Projects Phase 2

Phase Review

ROSE PARK IMPROVEMENTS

TD&H Job No. 16-211

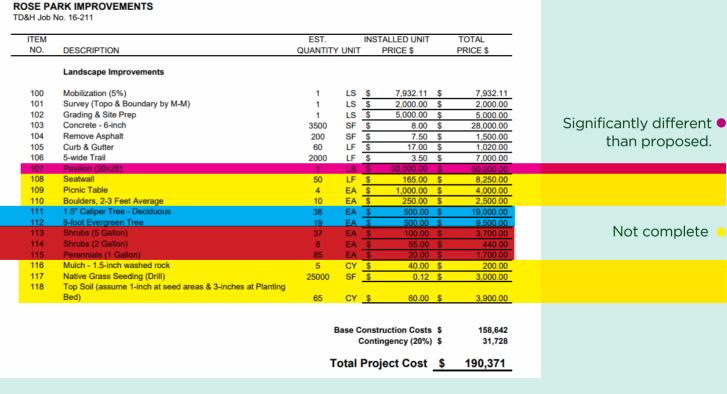
Shredded mulch not installed on any new tree or shrub per spec. from phase 1

Irrigation to perennials and shrubs is compromised

All perennials and shrubs are dead, mowed and/or trampled

Are there better landscaping approaches for these kind of planting areas?
